INDIANA DEPARTMENT OF TRANSPORTATION

July 19, 2017 Standards Committee Meeting

RE: Agenda for the July 19, 2017 Standards Committee Meeting

910.05 Castings

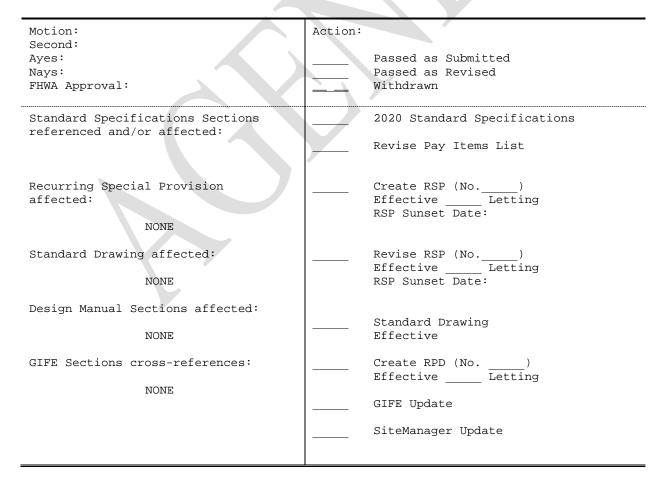
SECTION 910, BEGIN LINE 367, DELETE AND INSERT AS FOLLOWS:

The casting design shall be proof loaded to 40,000 lbs in accordance with AASHTO M 306. Castings shall be in accordance with the plan dimensions and to the following requirements for the designated materials. A certified inspection report shall be submitted by the manufacturer with each shipment of castings, except as otherwise provided herein. Inspection and testing shall be done by the manufacturer. The certified inspection report shall list the easting date, casting number, and the type of material, such as including the class of gray iron, and the grade of ductile iron. It shall state that inspection and testing has been performed, that all parts shipped meet the pertinent specification requirements, and that all component parts fit. The supporting test results, including proof load data, shall be retained and be available on request for a period of seven years. All castings shall have the manufacturer's identification and the date of manufacture cast on an exposed surface. Acceptance of castings will be based on the certified inspection report, visual inspection, and check measurements.
